1984 - 1987 Corvette: Chevrolet Central Office Letter to Corvette Owners: Roof Panel Damage

Subject: Roof Panel Damage

Model and Year: 1984 - 1987 Corvette

Date: April 1988

INSTALLATION INSTRUCTIONS

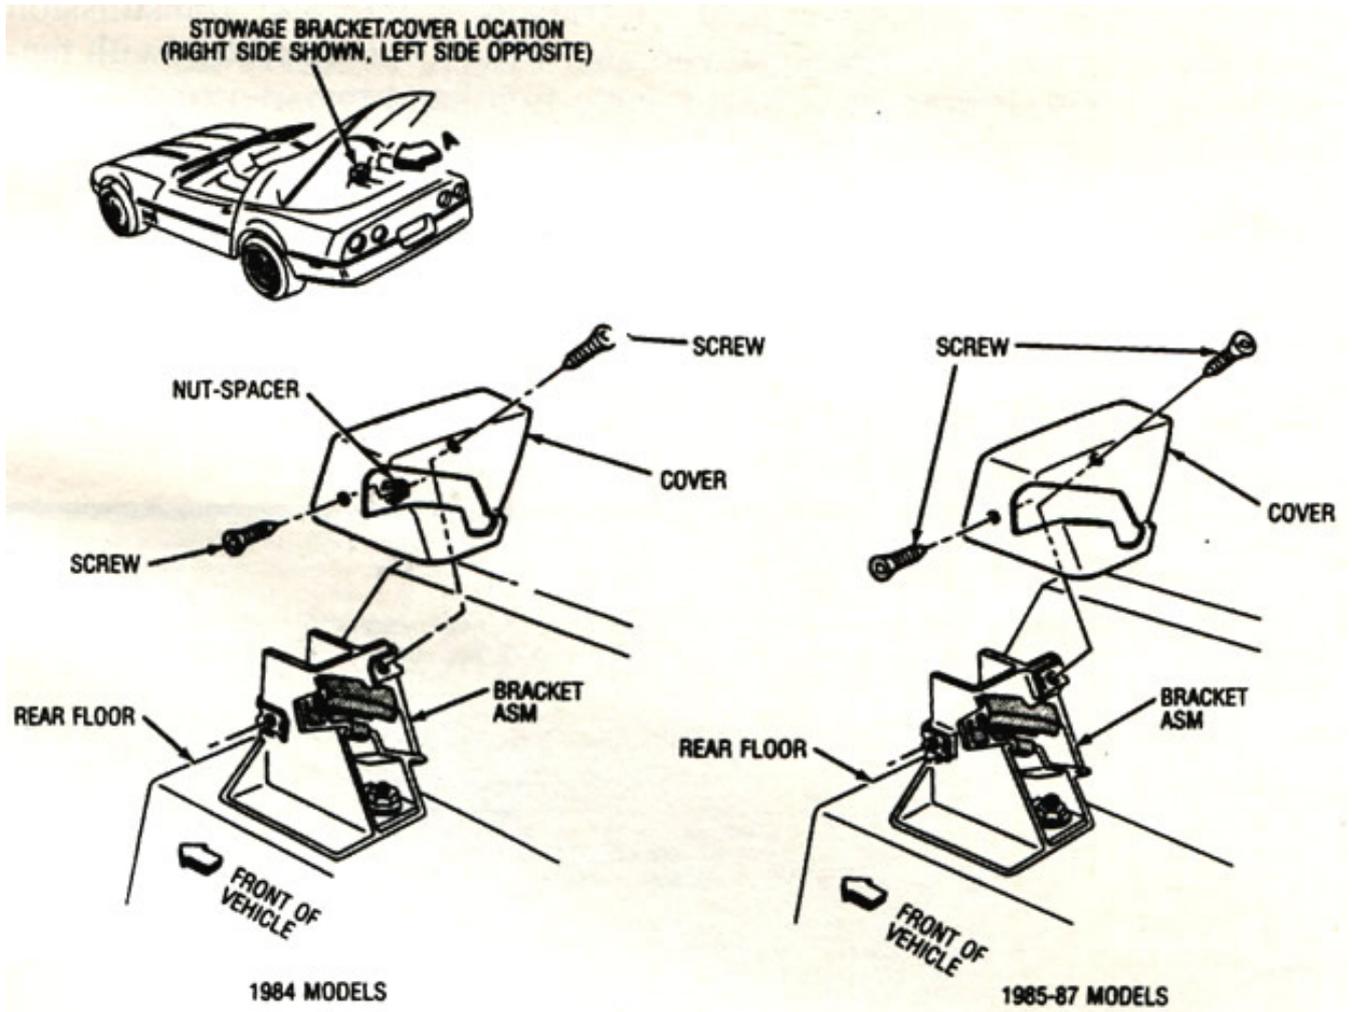
Attempting to lift the front edge of the top excessively while it is seated in the rear compartment stowage brackets, without sliding the top out of the brackets (as could possibly occur when attempting to stow items underneath the top), can lead to the top binding on the bracket covers. Forcing the top beyond this point may damage or crack the rear corners of the top resulting in a repair expense on the part of the owner which is not reimbursable.

Corvettes owners constitute a unique and very special group of Chevrolet customers. With this in mind, and in keeping with our commitment to customer satisfaction, Chevrolet is sending you new removable top stowage bracket covers for installation on your Corvette. These bracket covers allow for additional pivotal movement and will help ensure that no accidental damage occurs to your top. You can easily install the new bracket covers with only a Phillips screw driver by the following the enclosed set of instructions.

1. RAISE HATCH GLASS WINDOW.
2. REMOVE THE TWO SCREWS FROM EACH COVER (SCREWS WILL BE REUSED).
3. REMOVE THE ORIGINAL COVERS.
4. INSTALL THE NEW COVERS AND TIGHTEN THE TWO SCREWS

1. FOLLOW STEPS 1-3 ABOVE
2. INSTALL ONE OF THE SCREWS THROUGH THE INBOARD SCREW HOLE IN ONE OF THE NEW COVERS (SEE ILLUSTRATION).
3. PLACE A NUT-SPACER WITH THE WASHER SIDE TOWARD THE COVER ON THE PREVIOUSLY INSTALLED SCREW.
4. PLACE THE COVER BACK ON THE BRACKET, BEING CAREFUL NOT TO SHARE THE NUT-SPACER OFF THE SCREW. NOTE: THIS NUT-SPACER IS REQUIRED TO SUBSTITUTE FOR THE MOLDED IN FIN-SPACERS WHICH WERE ONLY ON THE 1984 COVERS.
5. RE-INSTALL THE SECOND SCREW AND TIGHTEN BOTH SCREWS, BEING CAREFUL NOT TO TIGHTEN THE SCREWS TO THE POINT OF DEFORMING THE COVER.
